Planning Commission
July 6, 2026 - 6:00 PM
233 South Main Street, Monroe, Ohio

- Case No. 2026-7-4- PUBLIC HEARING, Consideration of a Site Plan and Conditional Use Permit for Monroe Municipal Services Center

I. Case No. 2026-7-4—PUBLIC HEARING, Consideration of a Site Plan and Conditional Use Permit for the Monroe Municipal Services Center

MONROE MUNICIPAL SERVICES CENTER

SHEET IDENTIFICATION
C-103

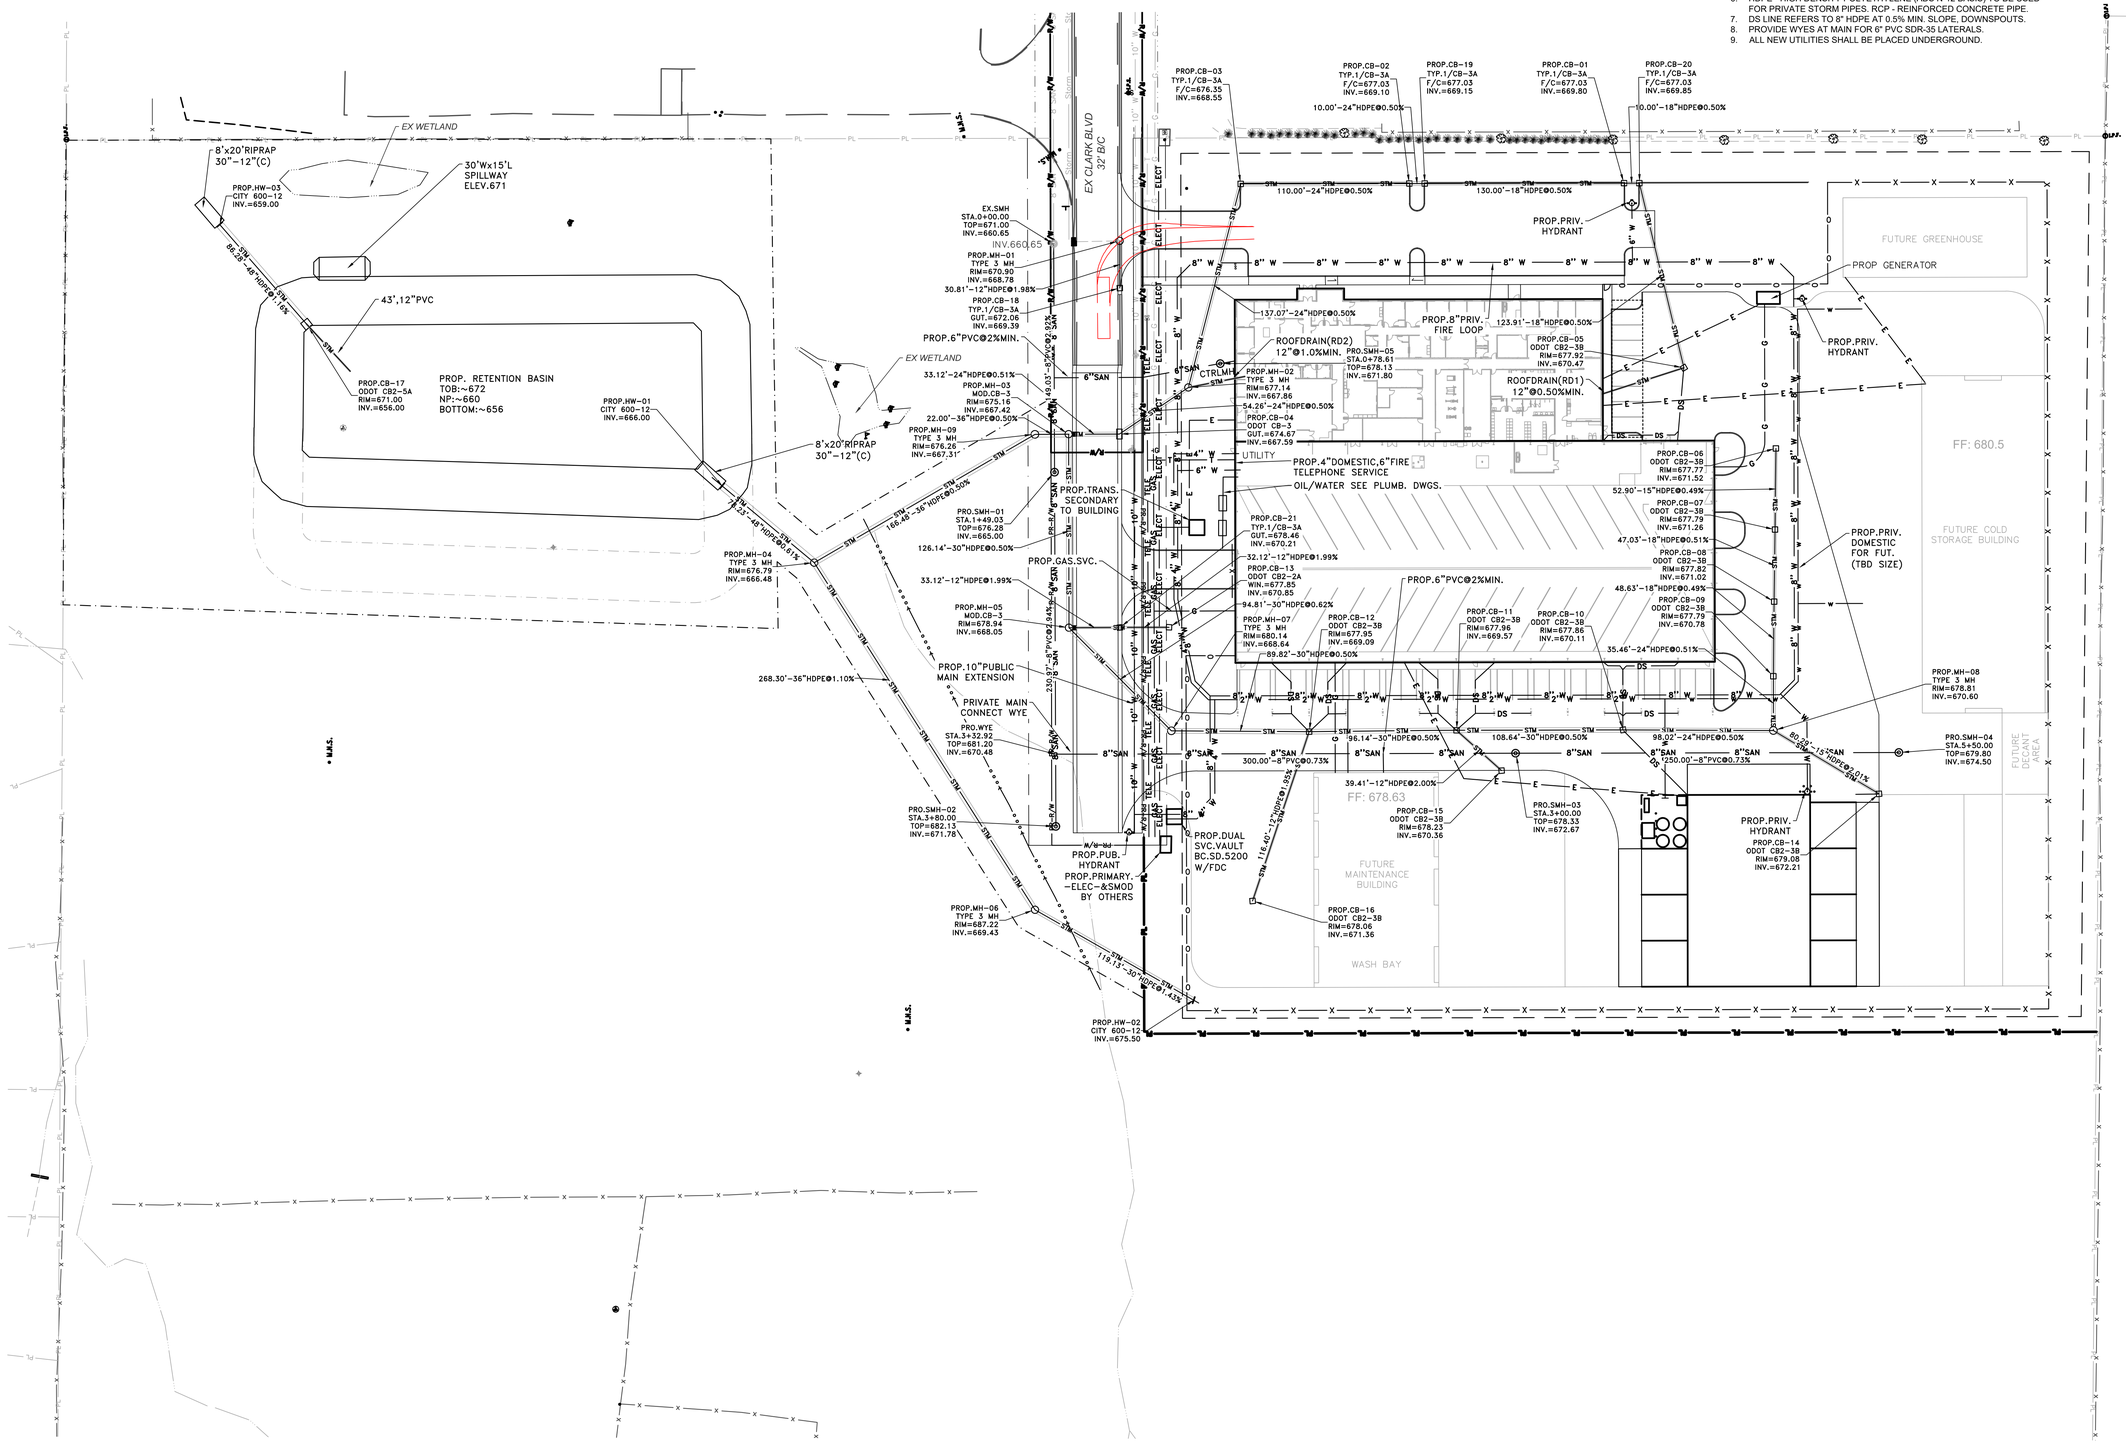
- Sheet C103: Multiple gates shown. Provide approved fire department access at all gates, including Knox locking devices.
- Sheet C103: Maintain drive access at all times during construction. Keep access clear of all materials and equipment. (See engineer detail.)

PRINCIPAL BUILDING ELEVATIONS

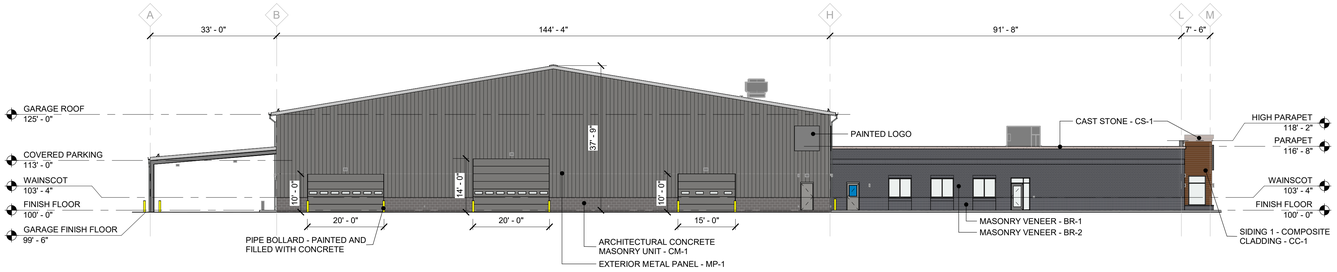
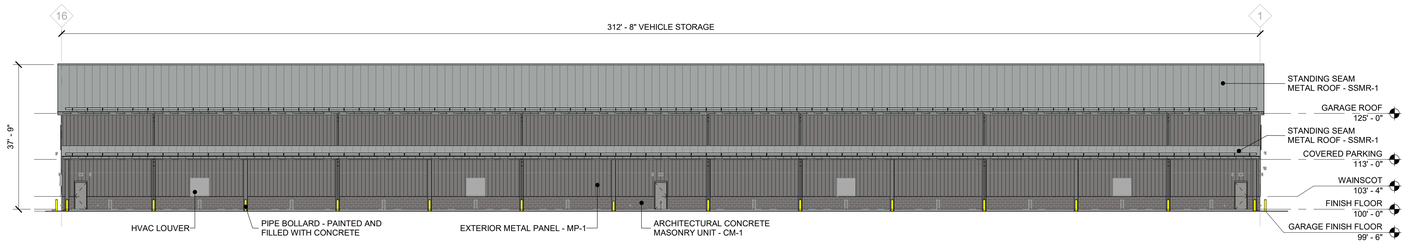
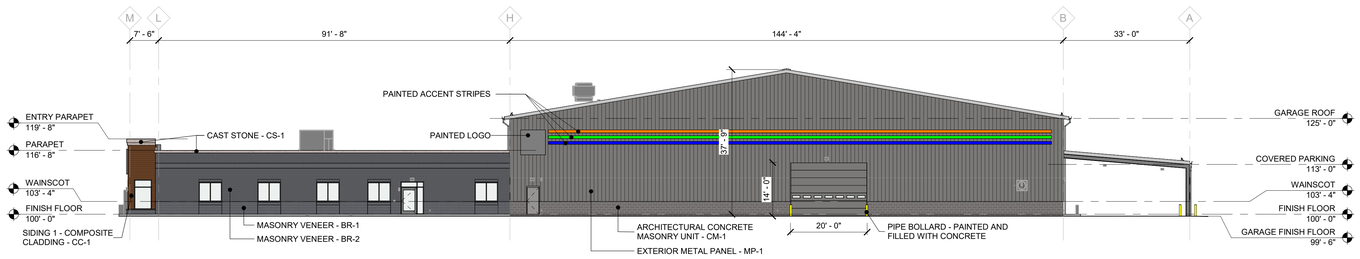
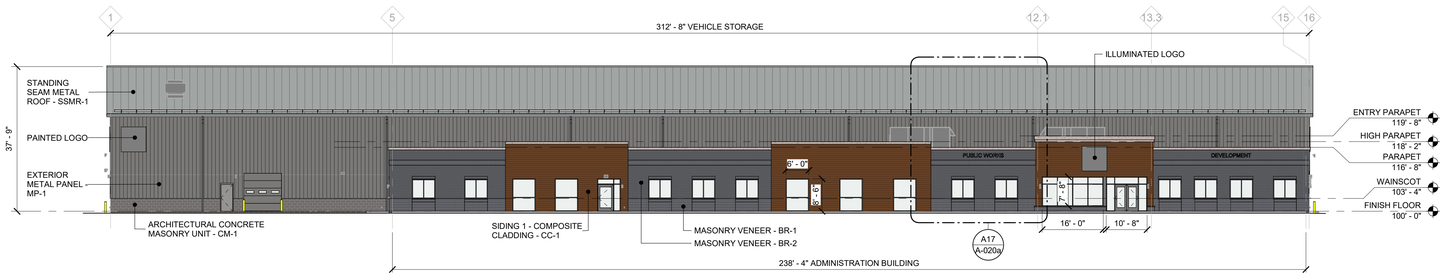
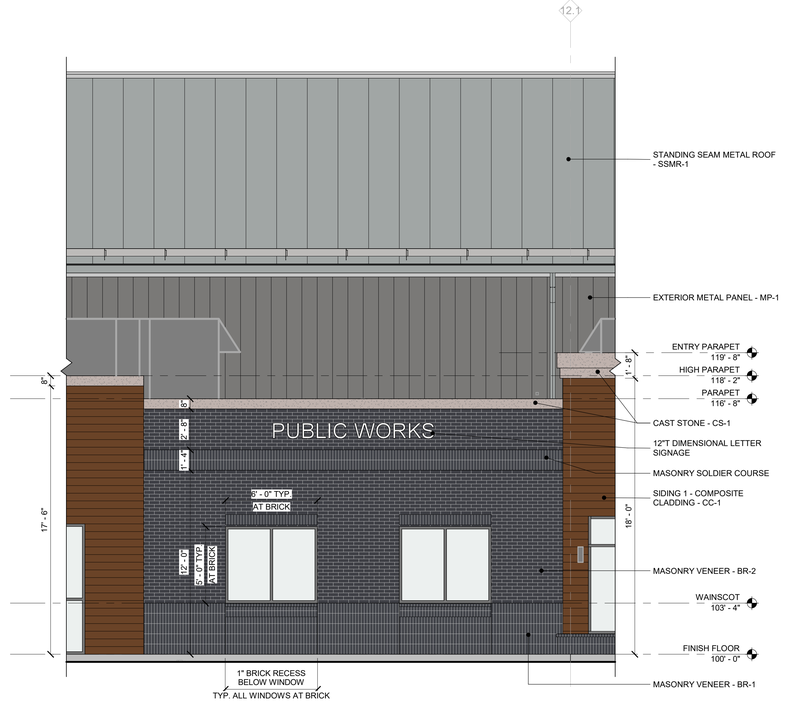
- **Architectural**
  - Base, Body, Cap Design Elements.
    - The applicant must show the Base, Body, Cap percentages on the elevations to ensure compliance.
      - The applicant has provided the elevations of the building showing the Base, Body, Cap percentages and comply with standards.

1 E-002 **SITE PHOTOMETRICS**
1" = 30'-0"

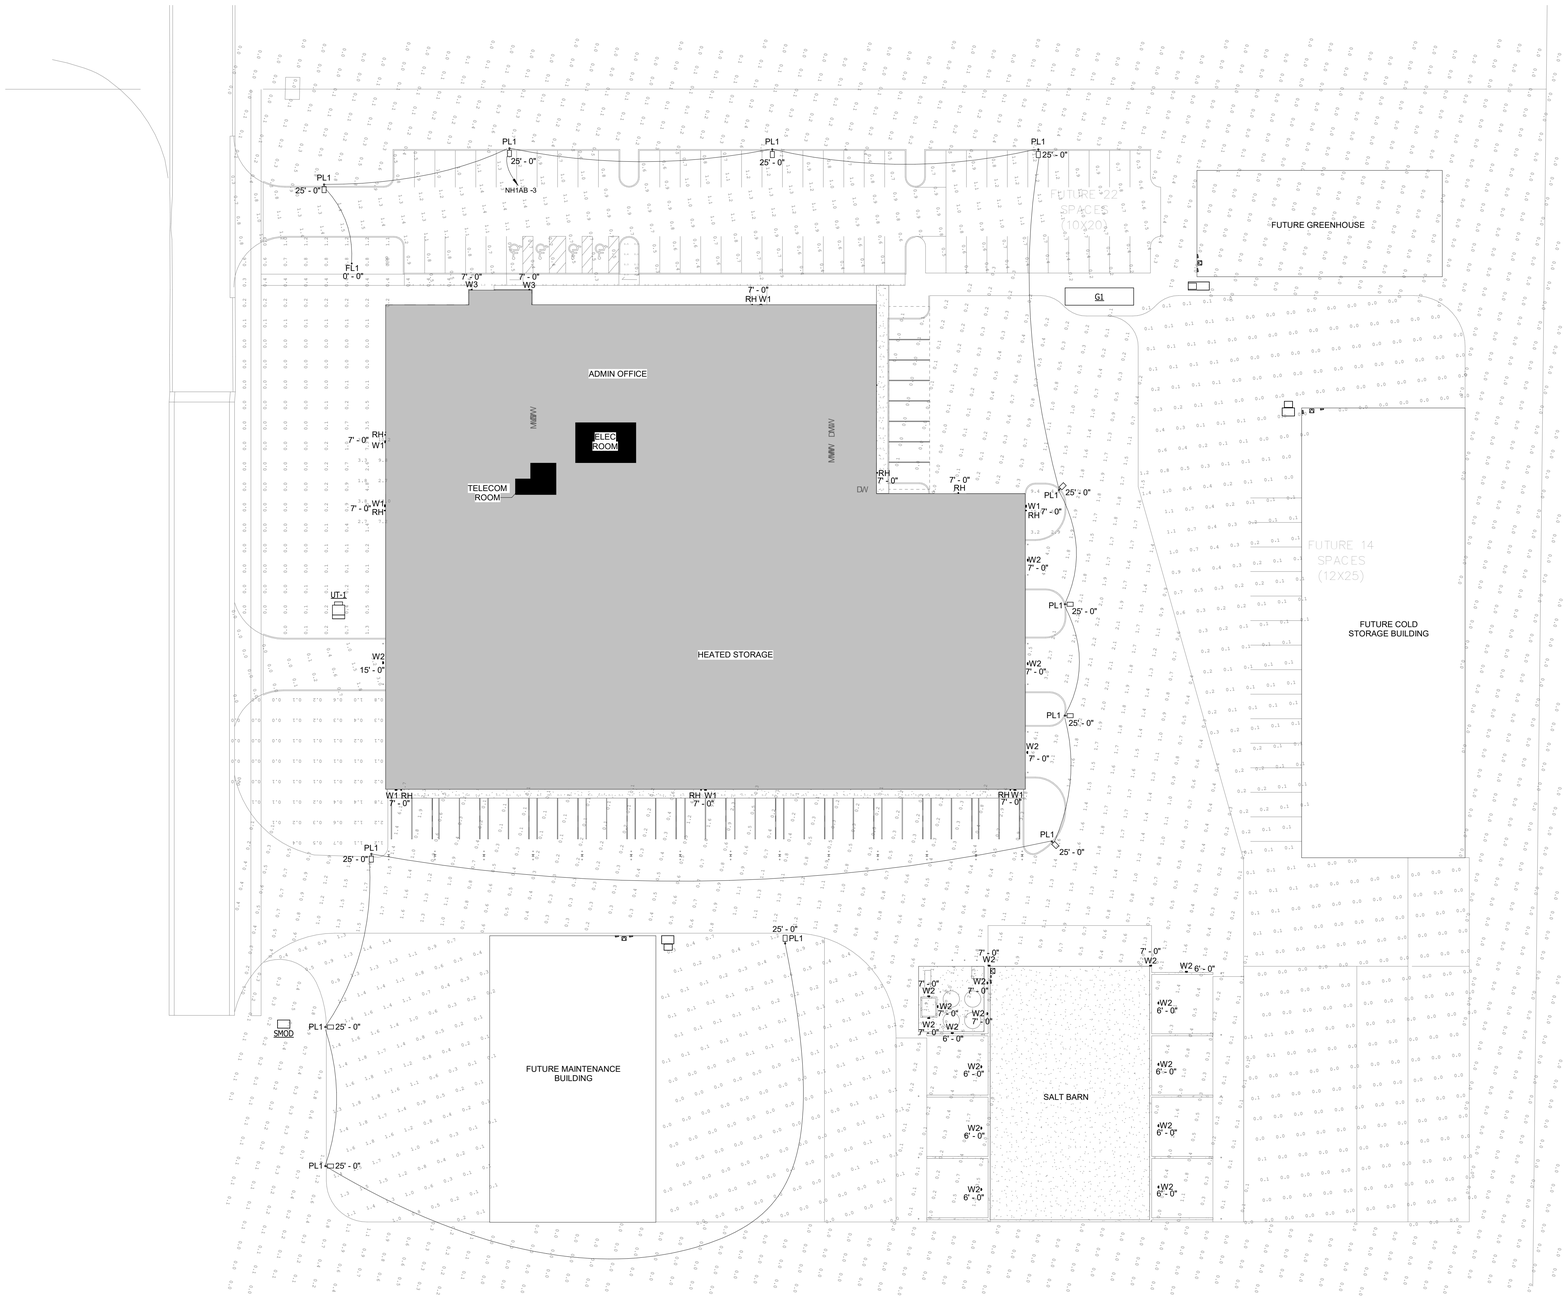
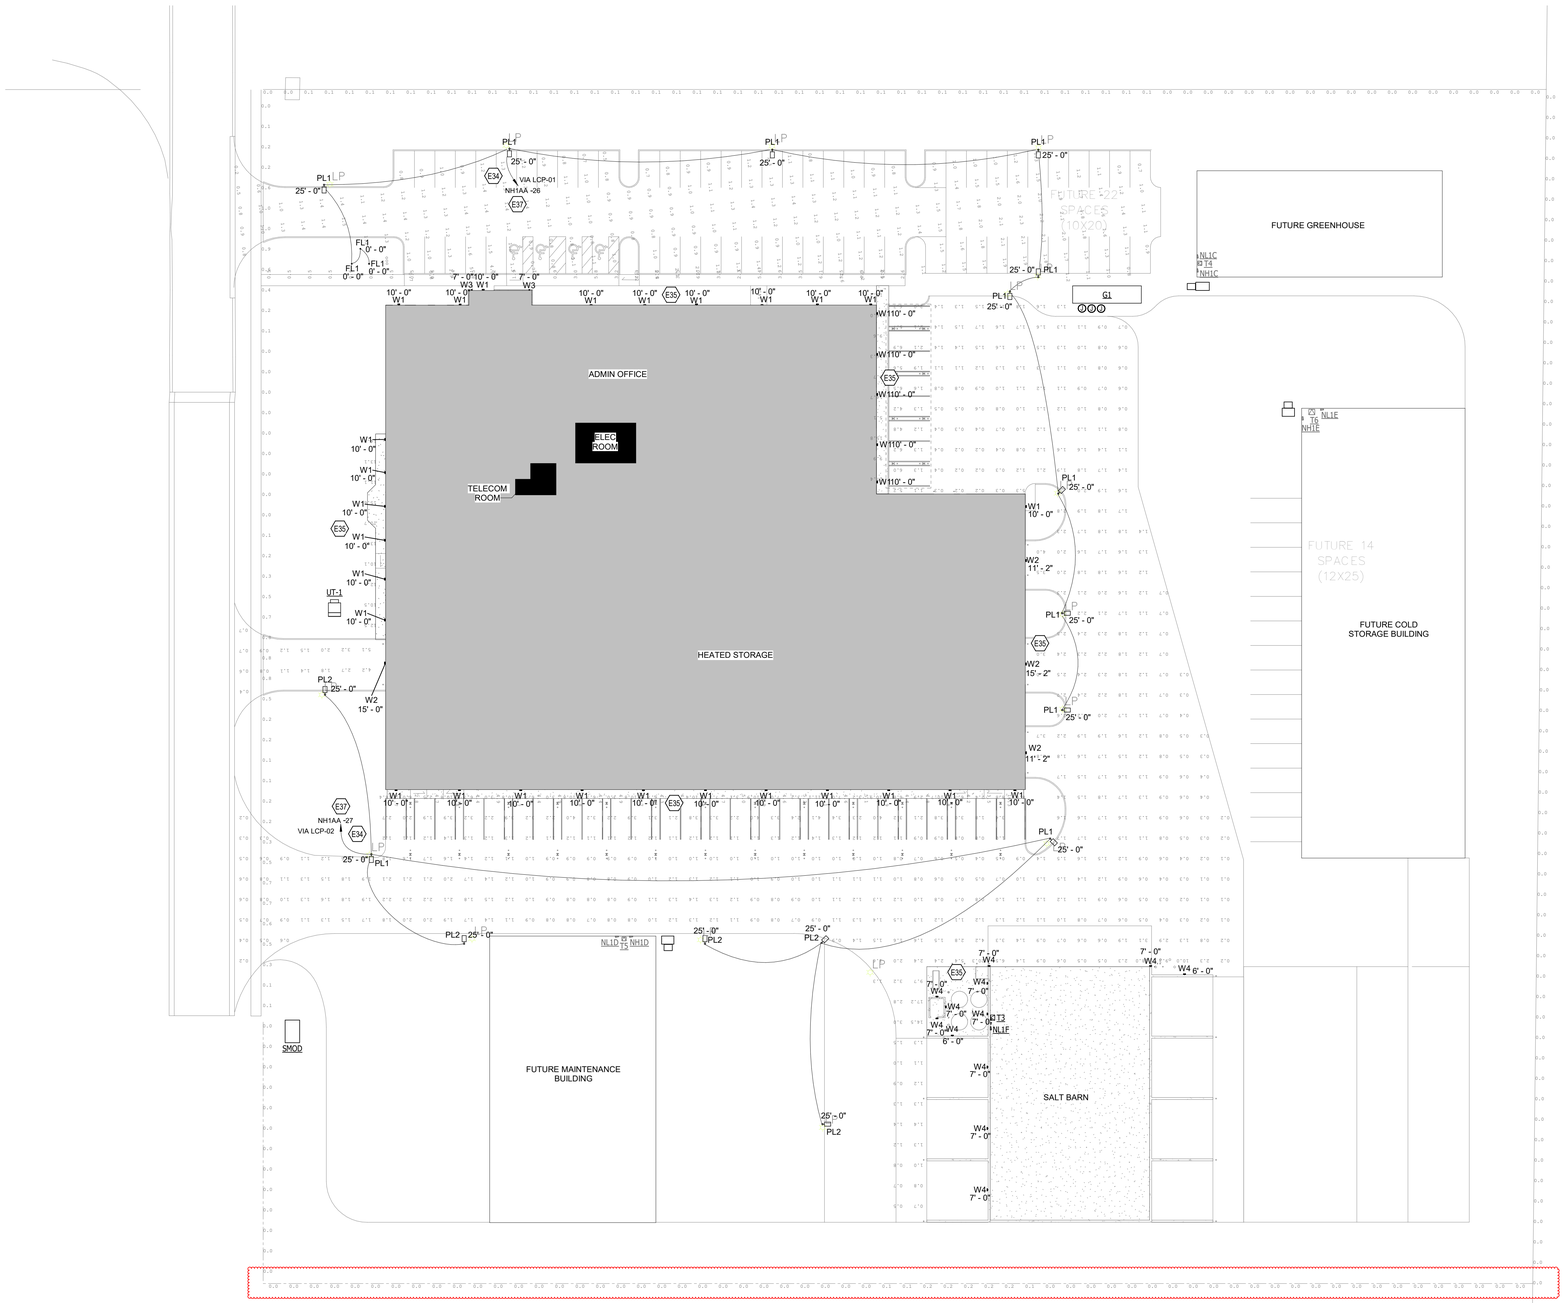
- **Photometric**
    - Illumination is required consistently across the site and shall be designed so as not to create dark spots that may create safety issues in such areas as vehicular use areas and connecting pedestrian paths.
        - The photometric plan is missing the southern property line. Please revise.
            - The revised photometric has been provided with the southern property line and meets code standards.
